**SUNDRY NOTICES AND REPORTS ON WELLS**

12. API No.: 49-009 -28281
13. County: CONVERSE
<small>Select Single Drill for State. In transactions on the reverse: If a Split Estate Location Change Provide Form 1A.</small>
5. Lease No.:
6. Unit Agreement or CA:
7. Farm or Lease Name: WEST ORPHA UNIT
8. Well No.: 33-73 14-1H
9. Reservoir: NIOBRARA
10. Field Name: PURPLE SAGE
11. Quarter- Quarter, Section, Township and Range: NE NW 14 Township 33 North Range 73 West
14. Elevation: 4949                  GL
16. Latitude: 42.8377
17. Longitude: -105.58735

Please see the revised footages:

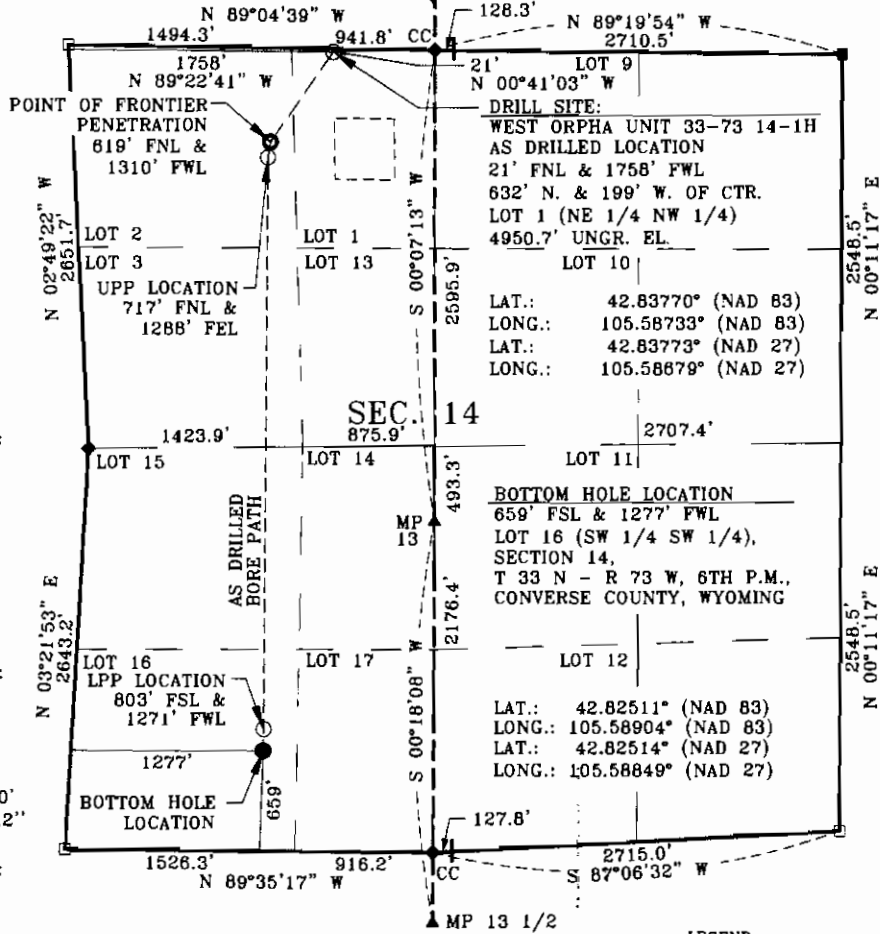
SHL: 21 FNL & 1758' FWL NENW LOT 1 Section 14-33N-73W  
42.83770; -105.58733

BHL: 659' FSL & 1277' FWL SWSW LOT 16 Section 14-33N-73W  
42.82511; -105.58904
